WGT Project
Impacts on HBCC area

Presentation by Andrew O'Brien

Monday, 4 September 2017

2031 traffic - no toll point west of Millers Road - about 11,000 trucks/day on Millers Road (Project Note 1 - Figure 7).

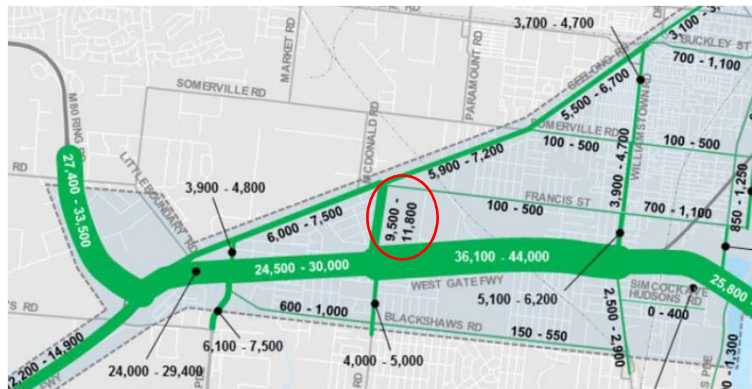
WITH a toll point west, Millers Road is about 14,000 trucks/day (7000 - 3000 additional) - an increase of 10,000 trucks/day. Both increases are unacceptable.

The Brooklyn Evolution Long-term Framework Plan (Next Slide) shows the proposed connection between Grieve Parade and Market Road.

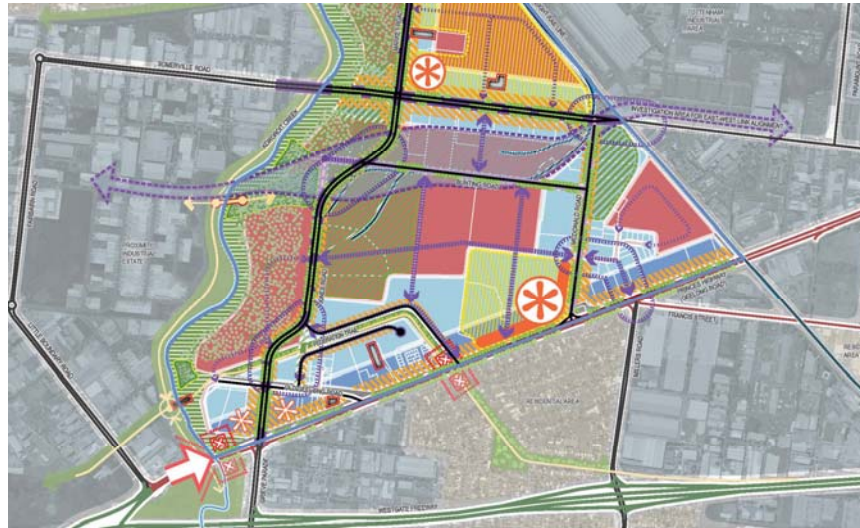
In my opinion, that link would provide significant relief to Millers Road as it would substantially reduce truck demands to use Millers Road.

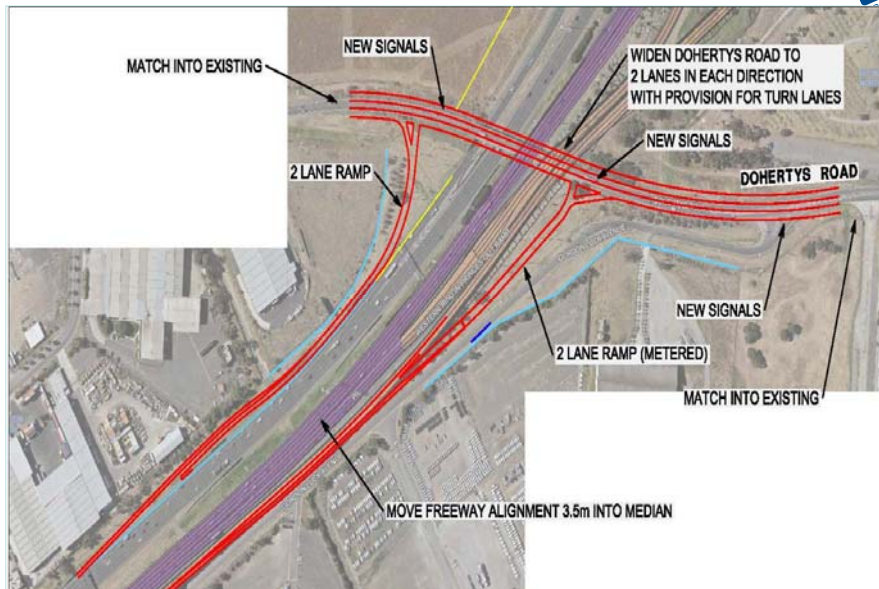
OBTR proposes west-facing ramps from Princes Freeway to Dohertys Road. The proposal has been modified slightly in response to VicRoads geometric objections - the eastbound exit has been moved to the west, and the westbound mainline widening proposed to be in the median - each to avoid acquisition.

In my opinion, that ramps would provide significantly safer and more direct access to the industrial areas both north and south of Princes Freeway east of Grieve Parade. It would relieve congestion on PHW at Lt Boundary Road and Grieve Parade, and make the M1/M80 interchange less congested.
